Comments on The Taylorville Energy Center Facility Cost Report

David A. Schlissel

April 16, 2010

Comment No. 9. The Pace Rate Impact Analysis is distorted by the assumption of high natural gas prices.

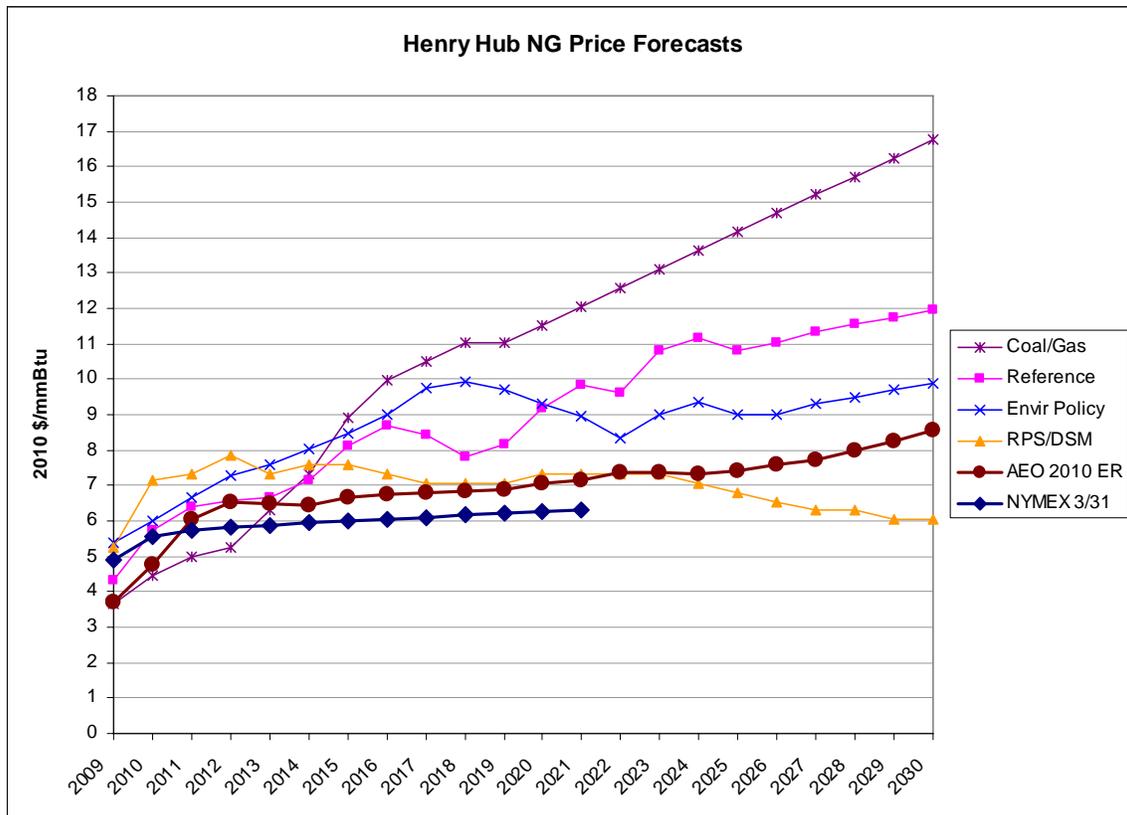
As can be seen in the following figure, the natural gas prices assumed in three of the four scenarios modeled by Pace (“states of the world”) are higher than current NYMEX future prices through 2022 and the most recent long-term price forecast from the Energy Information Administration (“EIA”) of the U.S. Department of Energy. In two of the four scenarios,

“Reference” and “Coal/Gas,” the natural gas prices are significantly higher than the current NYMEX prices and EIA forecast.

The lower NYMEX and EIA gas price forecasts are based on new estimates of domestic U.S. natural gas reserves. These increased natural gas supplies can be expected to exert downward pressure on gas prices as shown by the significantly lower NYMEX futures prices in the above figure.

Exhibit 63 – Delivered Price of Coal at TEC from All Subdivisions in Illinois, Graph, 2009 \$/mmBtu

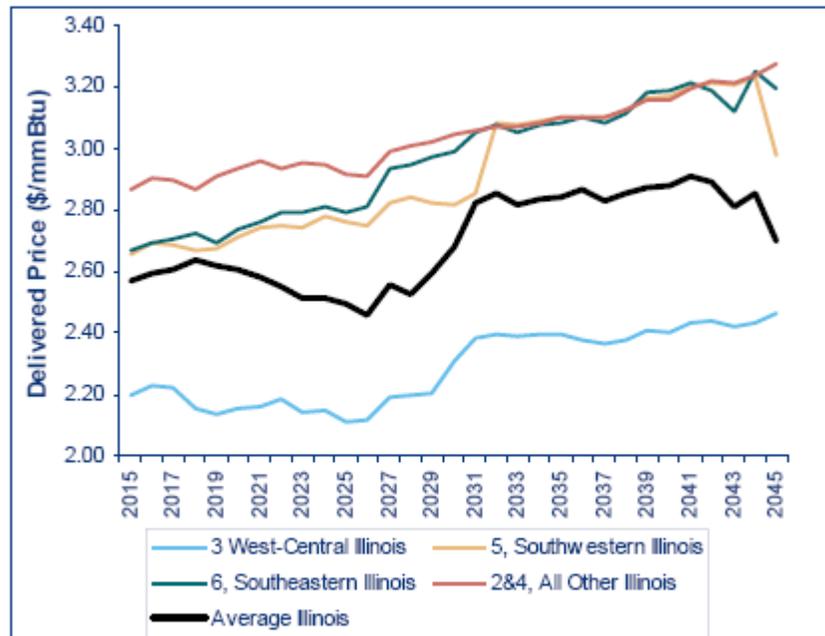
The price of coal will be significantly higher if TEC is unable to purchase coal from Subdivision 3 and/or that supply is disrupted for any reason.

As shown in Exhibit 63 from the Wood Mackenzie Report (Exhibit 6.0 to the Facility Cost Report), the delivered price of coal at TEC would be significantly lower in Subdivision 3 than from the other Subdivisions in the State of Illinois.

Consequently, the price of the coal used at TEC could be substantially higher is assumed in the Facility Cost Report, and the supporting Pace Rate Impact Analysis, if the plant is not able to obtain all of its supply from Subdivision 3 and/or if that supply is disrupted for any significant period of time. In fact, as shown in Exhibit 63 from the Wood Mackenzie report, in any particular year, the delivered price of coal from other Subdivisions in Illinois could be between 20 percent and 33 percent higher than the delivered price of coal assumed in the Facility Cost Report and Pace Rate Impact Analysis.
